SUBJECT: Consideration of tentative approval of the request by Novi-Ten Associates to rezone approximately 34 acres of land east of Novi Road, south of Ten Mile, to Community Business and Low-Density Multiple Family with a Planned Rezoning Overlay.

SUBMITTING DEPARTMENT: Community Development Department - Planning

Sheet Number:
PL-4

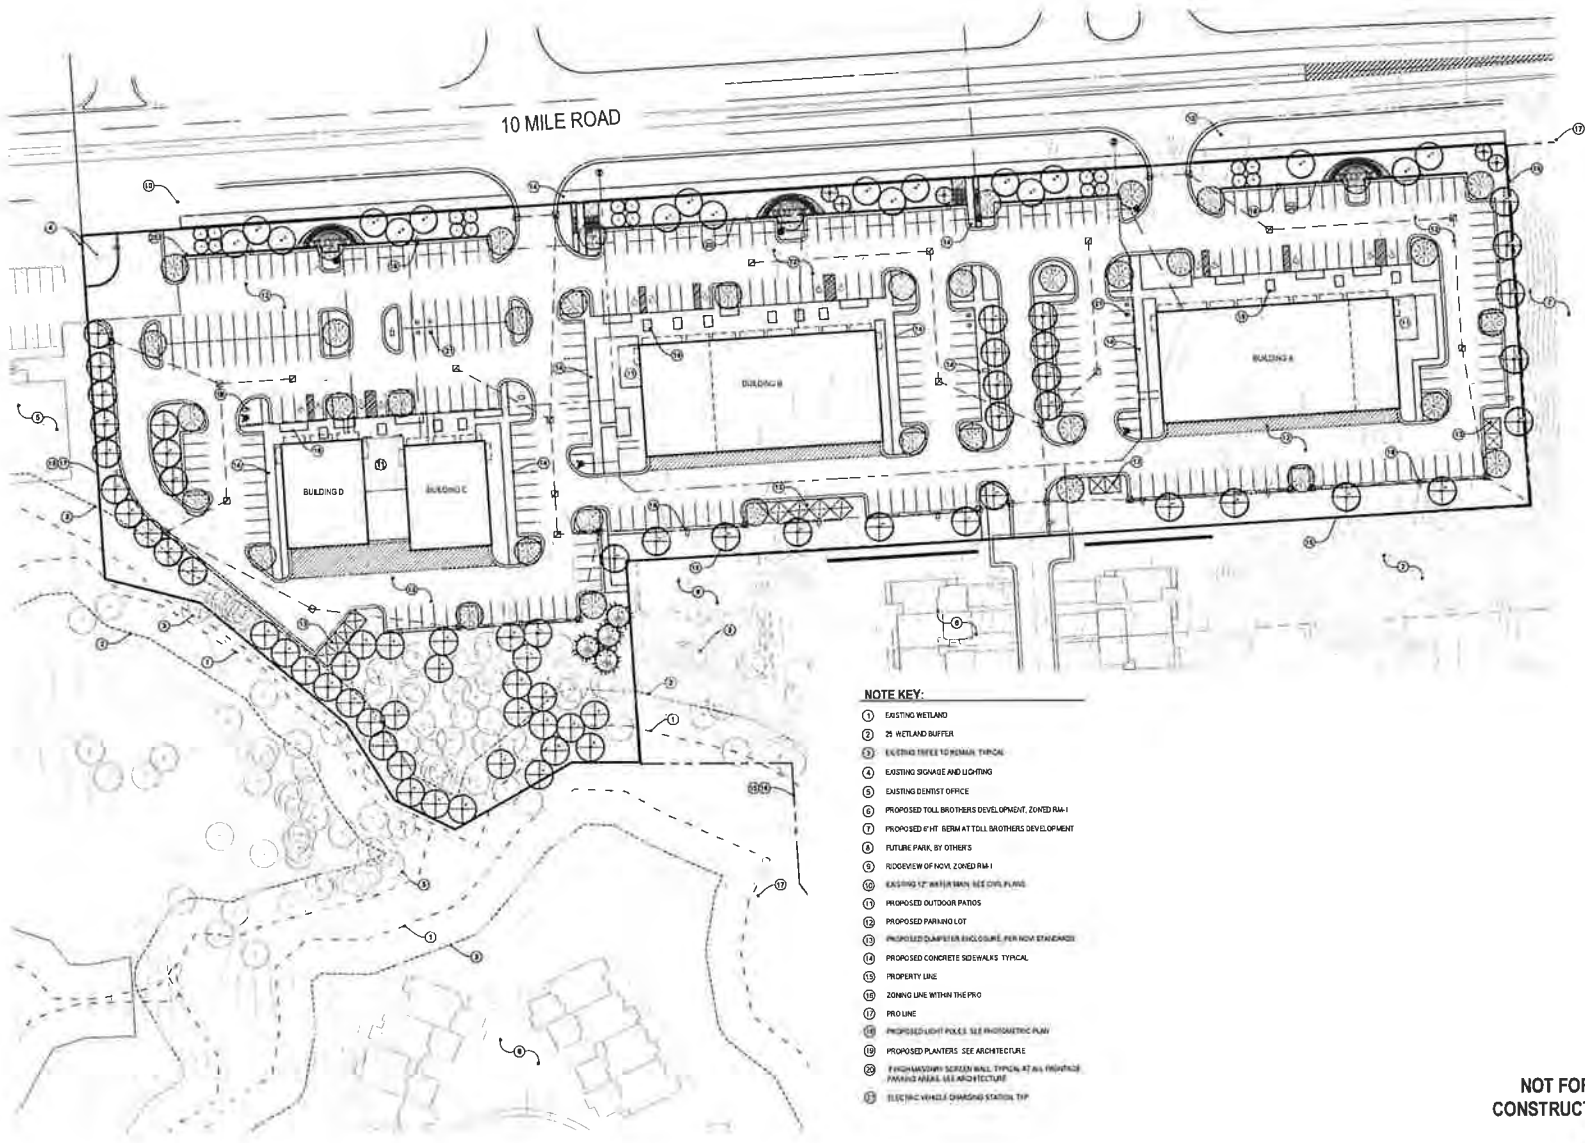
- Sheet PL-1 lists that 102 regulated trees will be removed but the sum of trees listed under the required replacements section is 108 trees (40+45+9+2+12). A potential error in summing the number of trees removed may have occurred. However, this does not impact the number of replacements required.

- a. The cost to stake, install, and remove the tree protection fencing should be added to Sheets PL-1 and RL-3 in order to calculate woodland fence inspection fees.

- b. The location and extent of tree protection fence should be added to the commercial site plan prior to final site plan approval; locations and diagrams of tree protection fencing have been included in the residential site plan. This can be added to Sheet PL-1 for the commercial site plan.
